la marzocco USA technical bulletin 202

Knob improvements on KB90 and GB5 S

December 12th, 2025

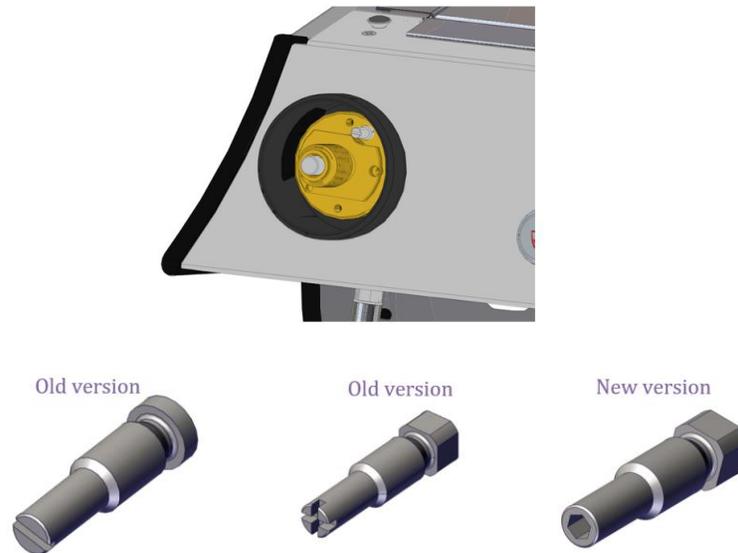
The brass slotted grub screw (I.4.005) used to adjust the adjust the valve activation, is now made of Acetal plastic with a hexagonal engagement (I.6.027).

Old version

New version

All KB90 and GB5 units manufactured after the serial numbers listed below include this update:

- GN004843
- KB005530

The component has also been updated in retrofit kit 1026, so you will find the new version included in the kit with your next order.
